Model	RDH for F40	Volt/Hz	Date of Modification	Serial Number
Modified Article	Parts Catalog			
Reason for Modification	Parts catalog correction

Please correct your parts catalog as follows:

Model	RDH for F40	Volt/Hz	Date of Modification	Serial Number
Modified Article	Separation belt and transport belt			
Reason for Modification	As per field request

Page 12

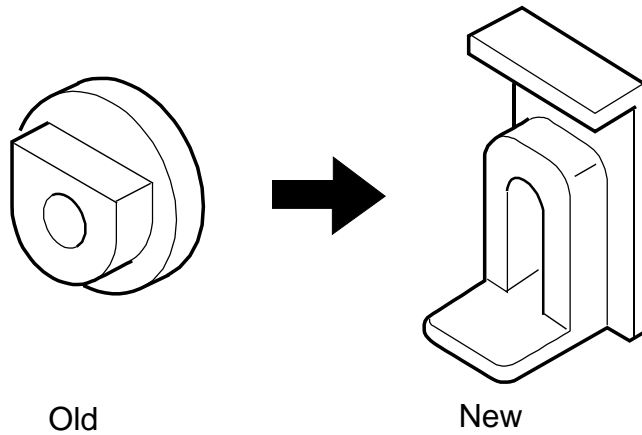
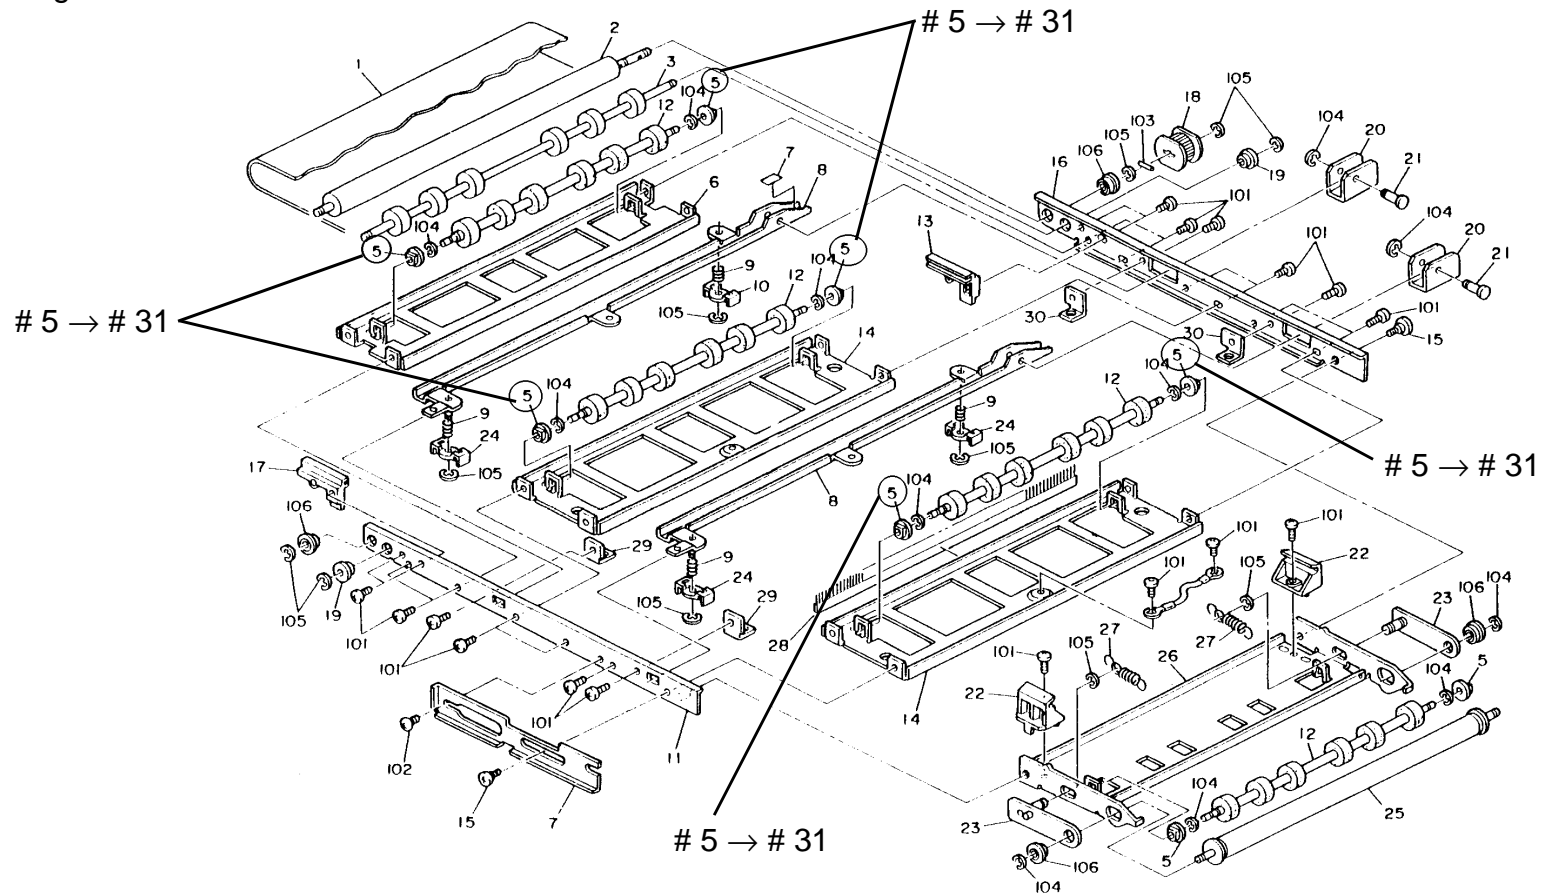
To improve durability, the shape of the bushings has been changed as shown.

Old P/N	New P/N	Description	Q'ty Used	Inter-change-ability	Parts Catalog	
					Index No.	Page
A4991616		Bushing - 4 mm	8 → 2	X/	5	13
	A3781616	Pressure Roller Busing	0 → 6	/O	* 31	13
